LINOTYPE IMPROVEMENT SHEET

NO. 299

TWO SPEED ASSEMBLER (NEW DESIGN)

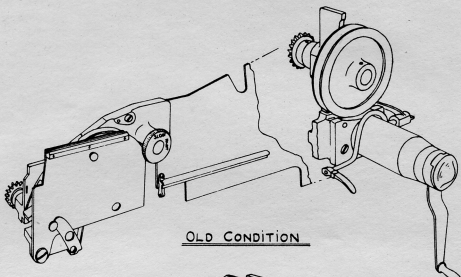
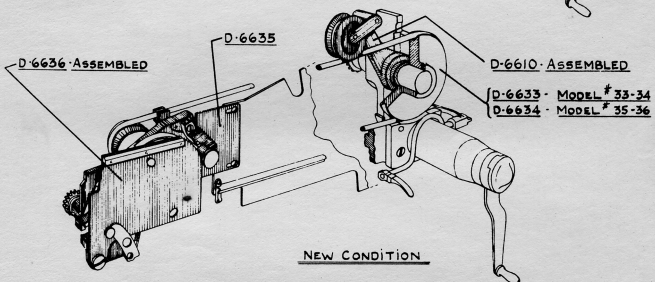
A new Two Speed Assembler has been designed using pulleys instead of gears for changing speeds. An Idler Pulley located at the Assembler Driving Pulley maintains a constant pressure on Belt while shifting or during regular operation.
